ROLLESTON PPC LARGE FORMAT RETAIL
ASSESSMENT OF NOISE EFFECTS

Rp 001 R01 20240014 | 19 February 2024

Addendum in Response to RFI Queries

Project:	Rolleston PPC Large Format Retail	Document No.:	Mm 001
To:	C/- Aurecon	Date:	13 August 2024
Attention:	Selwyn District Council	Cross Reference:	
Delivery:	Email	Project No.:	20240014
From:	Rob Hay	No. Pages:	3
		Attachments:	No
Subject:	PC240002: Private Plan Change Request to the Partially Operative Selwyn District Plan (V2) by Foodstuffs (South Island) Properties Limited at 157 Levi Road, Rolleston – Request for Further Information (RFI) – Acoustics Response

APPENDIX B INDICATIVE SITE LAYOUT

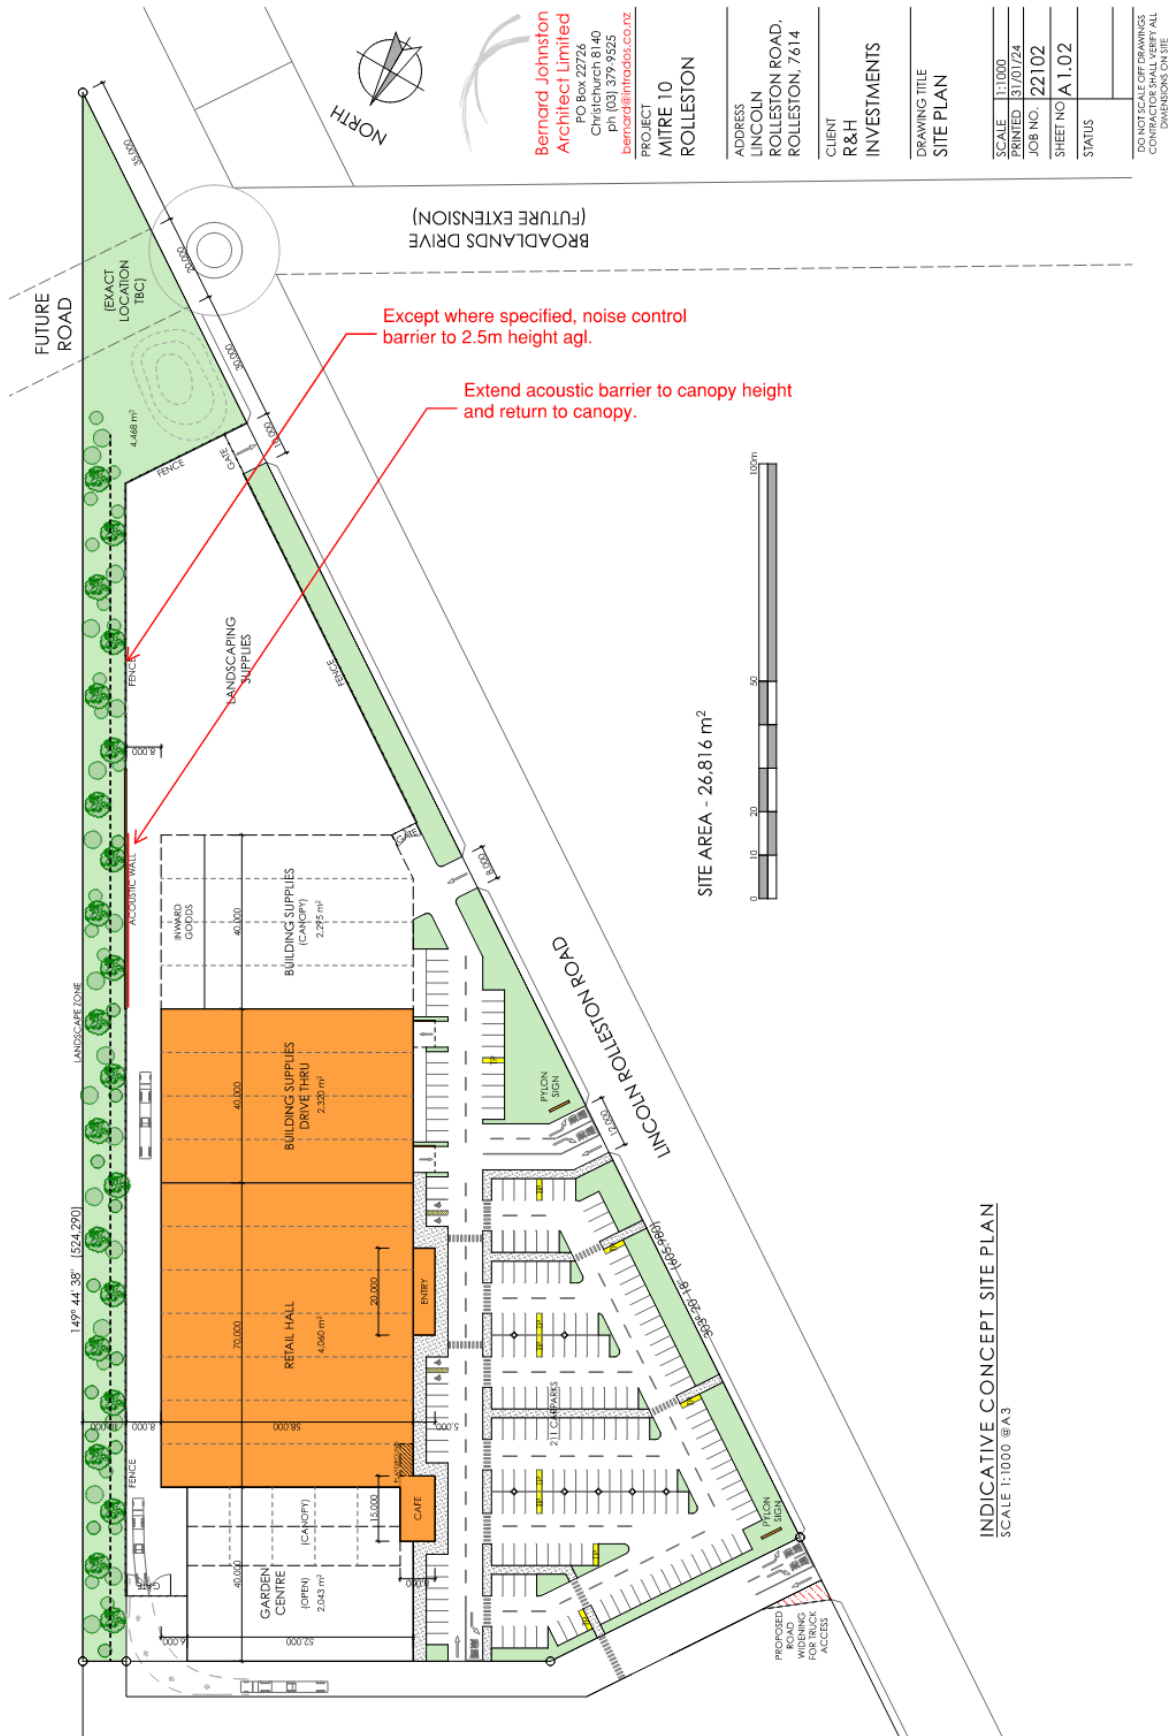
Please amend the ODP to show all appropriate noise mitigation measures considered appropriate by MDA

I have informed amendments to the ODP to include all noise mitigation measures that I consider appropriate for a rezoning, knowing that these will operate in conjunction with the noise standards in the District Plan to achieve an acceptable noise outcome for the site and its setting.
